Docket Item # 7  
BAR CASE # 2010-0032

BAR Meeting  
April 28, 2010

**ISSUE:** Addition/Alterations

**LOCATION:** 1026 Queen Street

Figure 2. Proposed north and south elevation

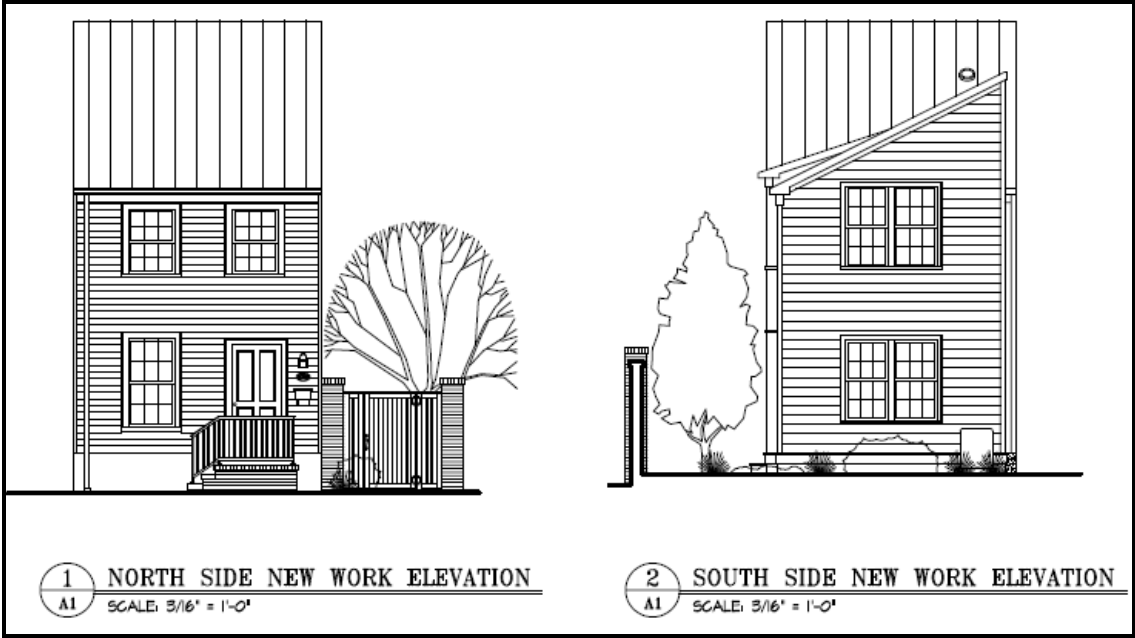
The alterations to the historic main block consist of replacing all three, six-over-six windows with new six-over-six double hung windows on the front façade and all five, six-over-six windows with new six-over-six double hung windows on the west elevation. A new wood four panel front door is also proposed. The historic cornice will be repaired and retained. The applicant proposes to install a new Kichler Mount Vernon porch lights with a bronze finish to the left of the front door. On both the front facade and the west elevation of the addition the applicant proposes the instillation of painted white metal gutters and downspouts.

The applicant is proposing new 5 inch reveal wood lap siding to replace the existing siding on the North, East, and West elevations of the historic house, in addition to new wood trim and corner boards. For the addition, the applicant proposes to install five inch reveal Hardieplank fiber cement siding and azek trim.

In Staff's opinion, the six-over-six windows on the historic house (the three windows on the front façade and the five windows on the west facing elevation of the main block) should be single glazed with true divided lights with the option of exterior storm windows, in order to maintain the historic integrity of the main block. Staff supports the use of double insulated windows on the new addition, for the same reasons Staff supports the use of Hardieplank siding in this location, because they will be located on new construction. In the same vein, Staff does not object to an insulated glass paneled door. Staff finds the proposed light fixtures and gutters to be compatible to the style of the house and the historic district. Additionally, staff supports both the design of the stoop, steps and railing as well as the new fence and garden wall. Therefore, staff recommends approval of the application with the following conditions:

1. That the applicant use a single glazed, true divided, wood window with the option of storms for all 8 replacement windows on the historic house, and that final specs be submitted to staff for approval prior to application for a building permit.
